APPEAL RECOMMENDATION REPORT

City Planning Commission

Case No.: ZA-2018-7378-ZV-TDR-SPR-1A

PROJECT LOCATION: 1123-1161 South Main Street; 111 West 12th Street

② *Transverse Section-Spacing Diagram
1" = 20'-0"

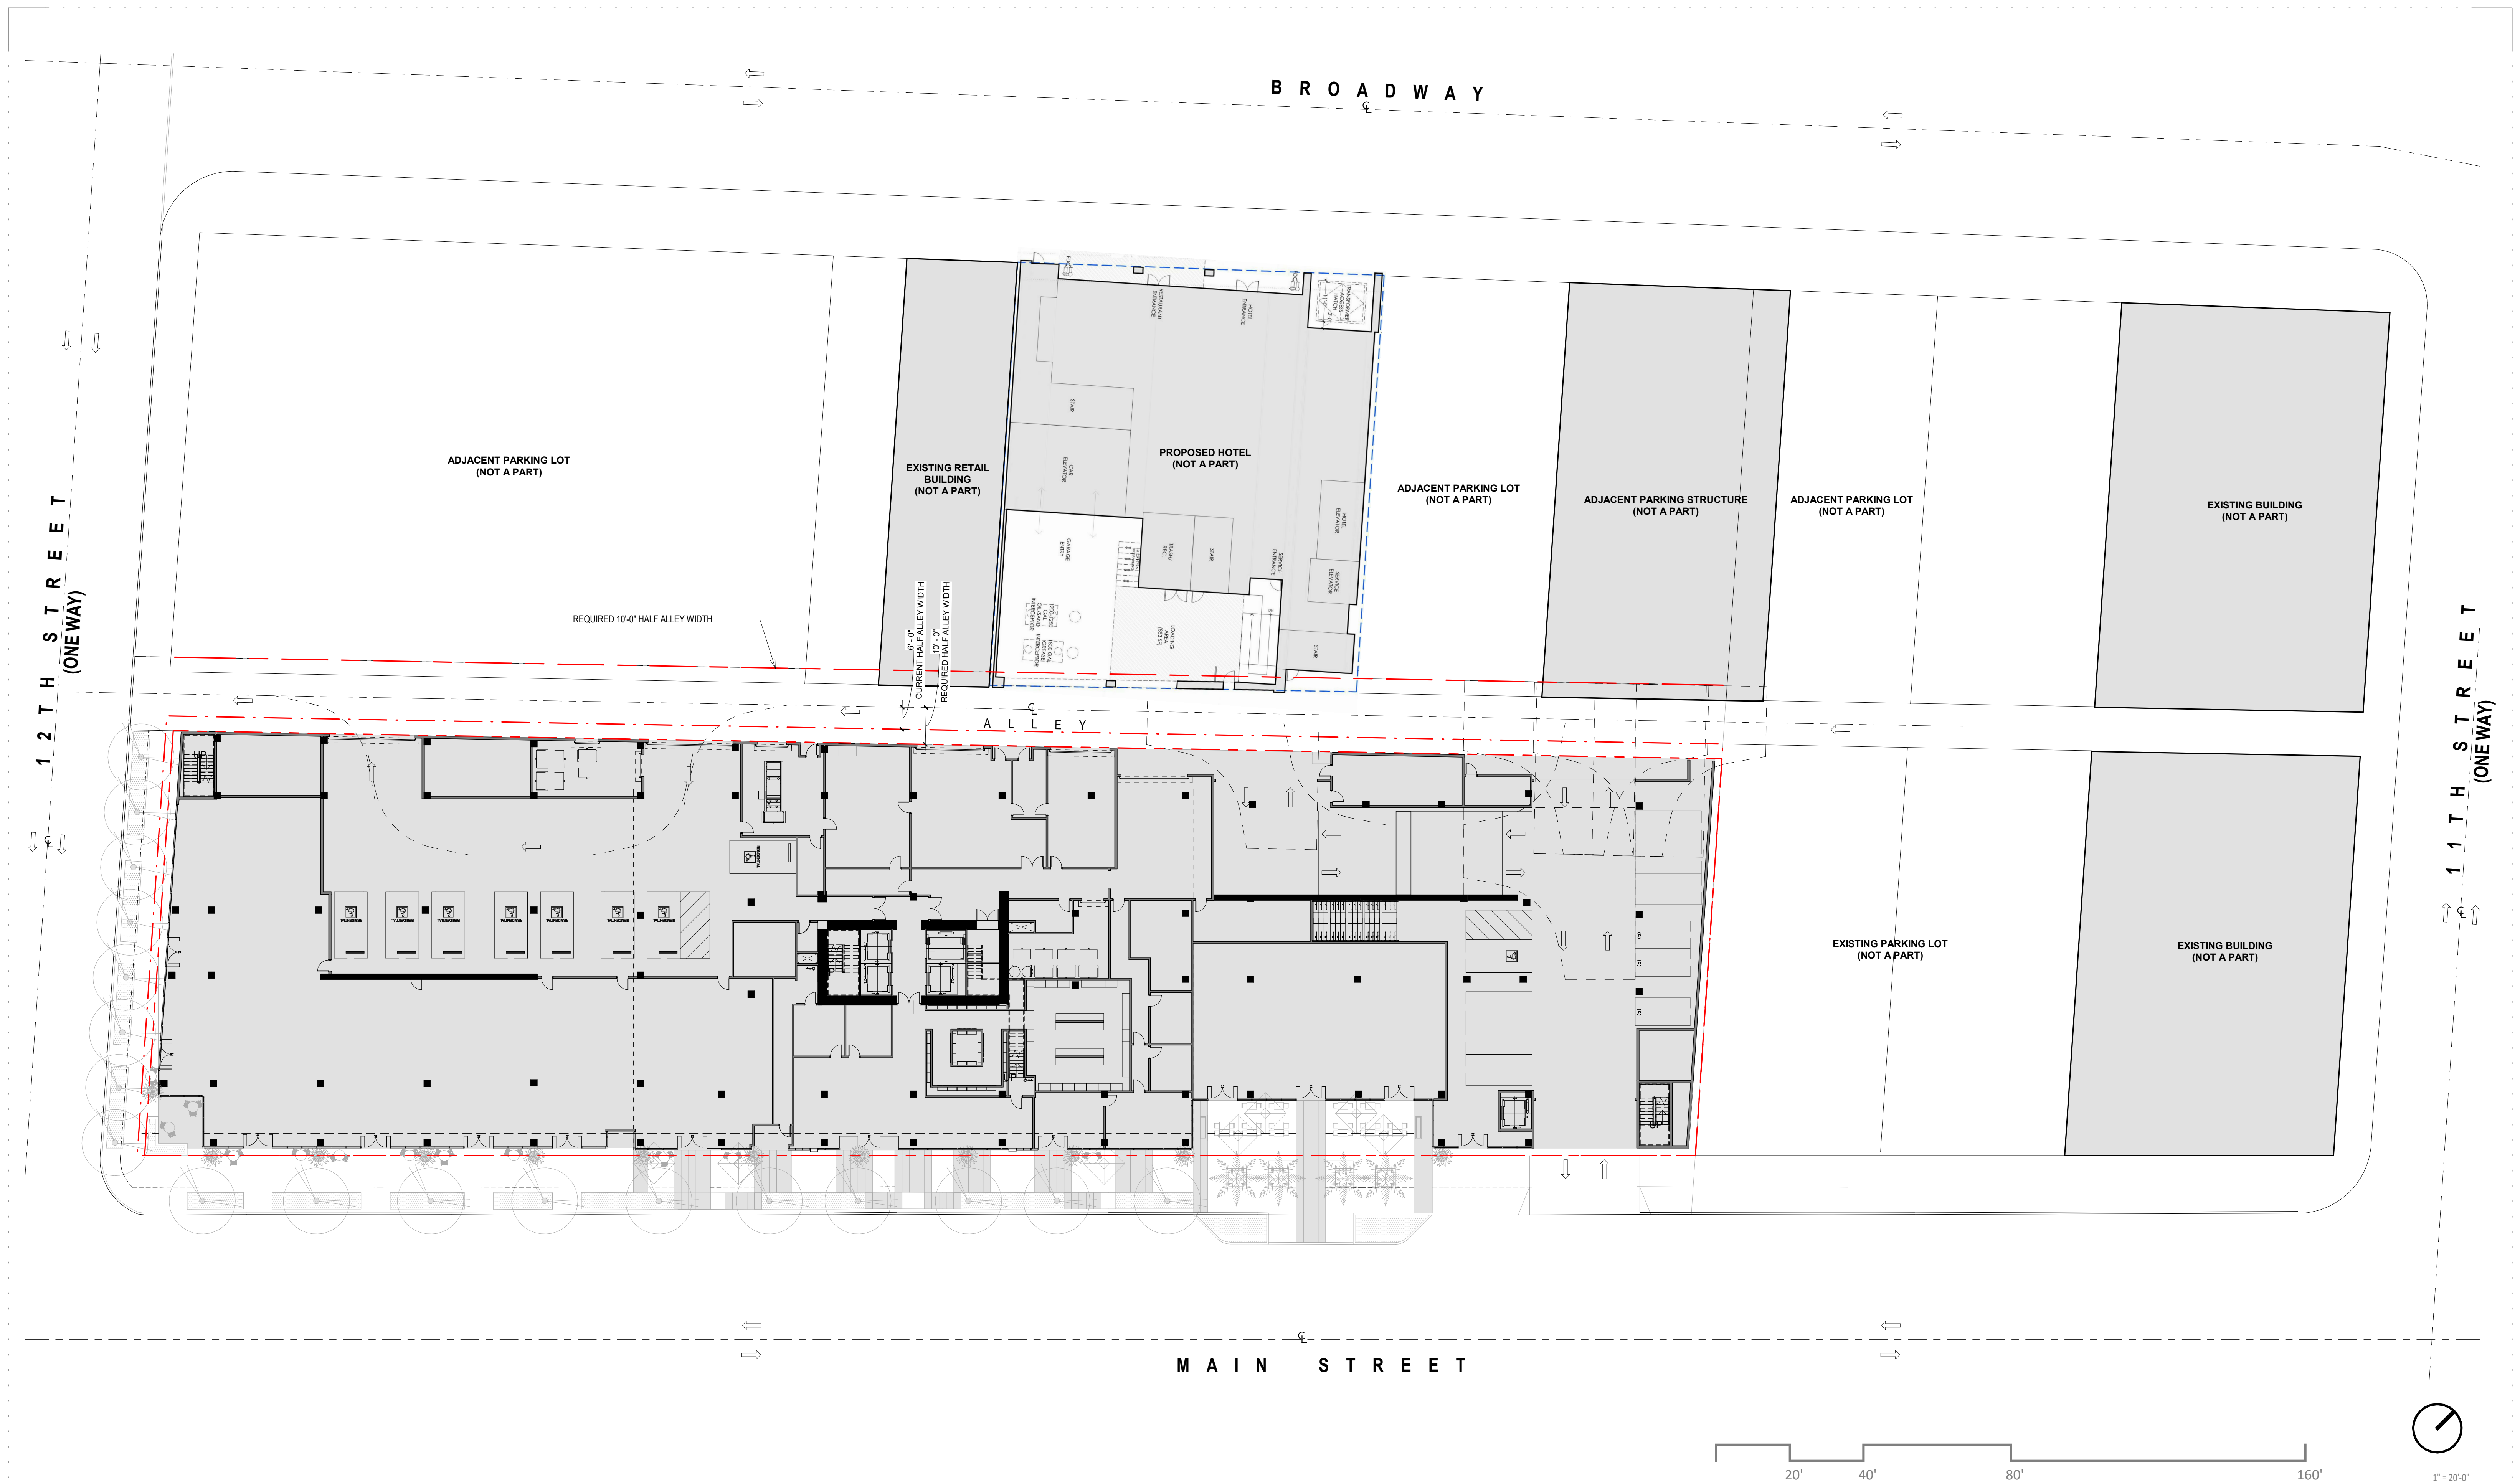
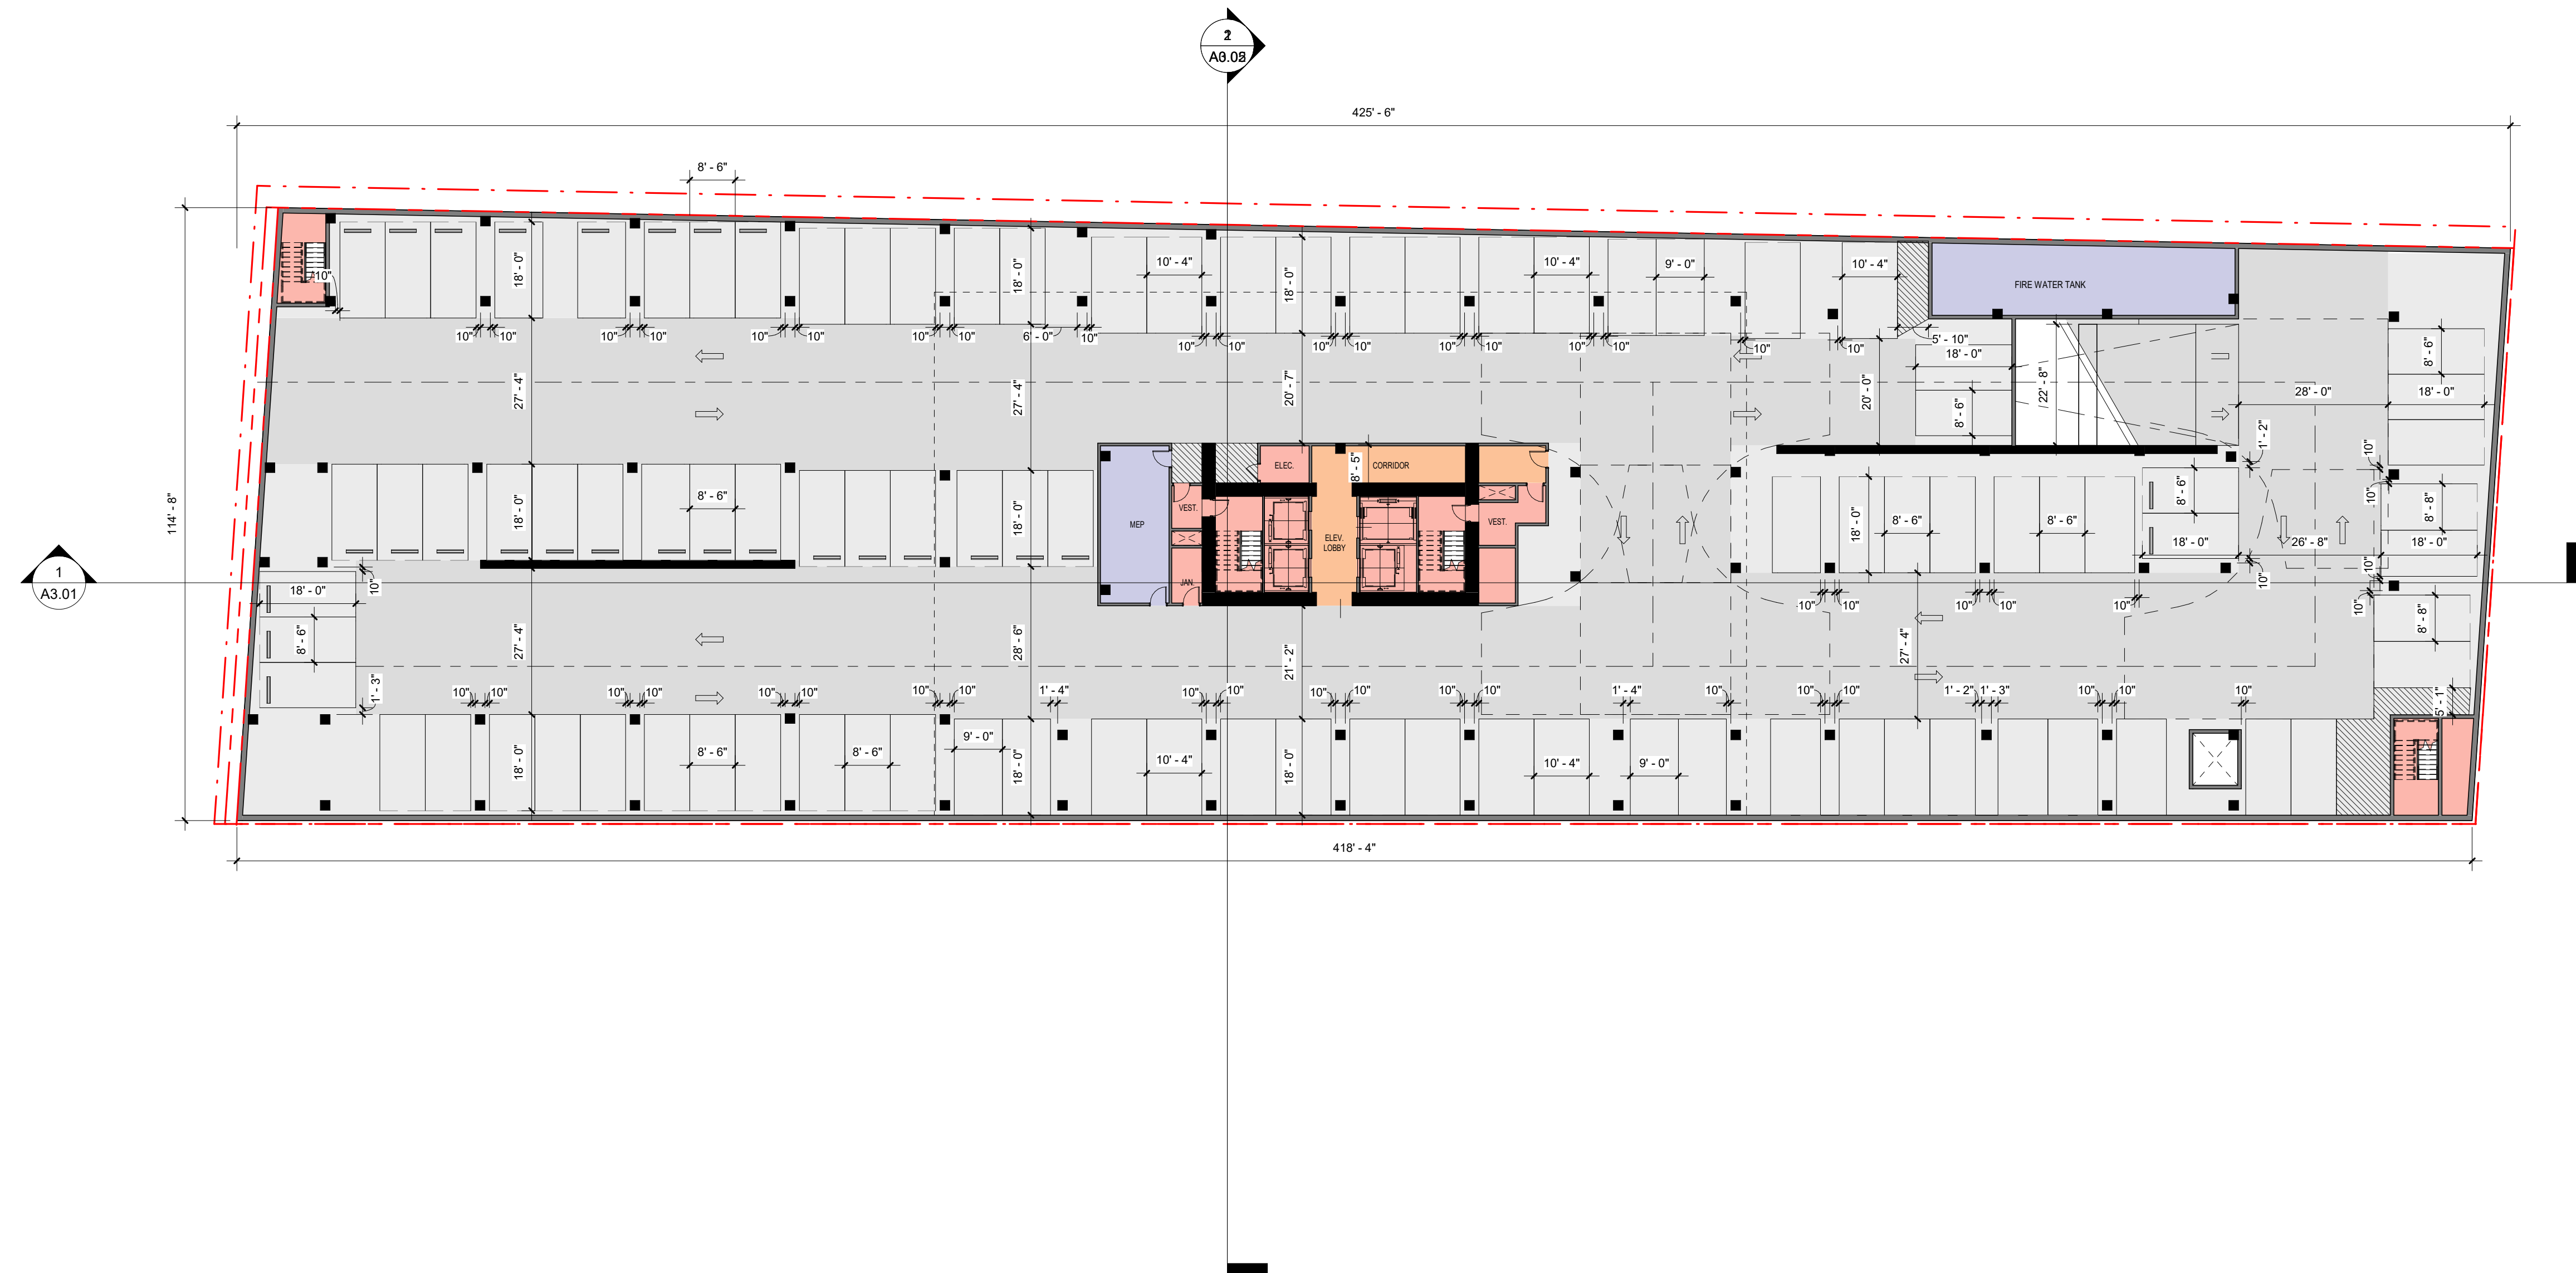
The Project's building (tower) arrangement, height, bulk, and setbacks are not compatible with the hotel abutting the Subject Property northerly. The tower would be better situated southerly, away from the hotel. Therefore, the Site Plan Review should not be granted for the Project's current design.

Regarding arrangement and setbacks, the project site is not subject to any setback limitations per the Greater Downtown Housing Incentive Area. Furthermore, the Downtown Design Guide requires the building street wall adjacent to retail use to be located at or within zero to five feet from the required sidewalk easements to activate streetfronts. As such, the proposed building is encouraged to be built close to, if not at, the property lines. Additionally, as previously mentioned, the Downtown Design Guide regulates space of towers, and as illustrated on Sheets 0.04 and 0.05 of the project plans (Exhibit A), the project tower is proposed to be offset or staggered from the tower proposed at the appellant's property at 1140 South Broadway. The proposed tower is separated from the 1140 South Broadway tower by approximately 71 feet and maintains sightline distances of greater than 40 feet between two buildings as required by the Downtown Design Guide.

- c. **Tower Spacing.** The proposed tower shall be located a minimum of 71 feet from the proposed hotel tower located at 1140 South Broadway, as shown on Sheet **s A0.04 and** A0.05 of Exhibit "A" **stamp-dated August 18, 2022.**
